AEA COMMENTS TO

NOTICE OF PROPOSED RULEMAKING (NPRM)

**REDUCTION OF FUEL TANK FLAMMABILITY IN
TRANSPORT CATEGORY AIRPLANES**

May 02, 2006

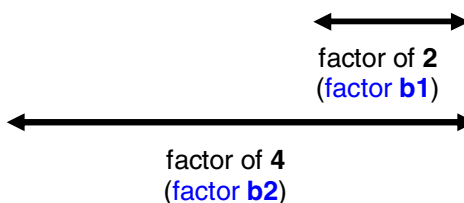
Historical data shows 3 accidents in 420 million FH, resulting in an accident rate of 1 per 140 million FH (420 / 3 = 140).

The corrected predicted number of accidents is then 468/140 = 3.34 accidents

This is a correction factor of **2.33 (factor a)**
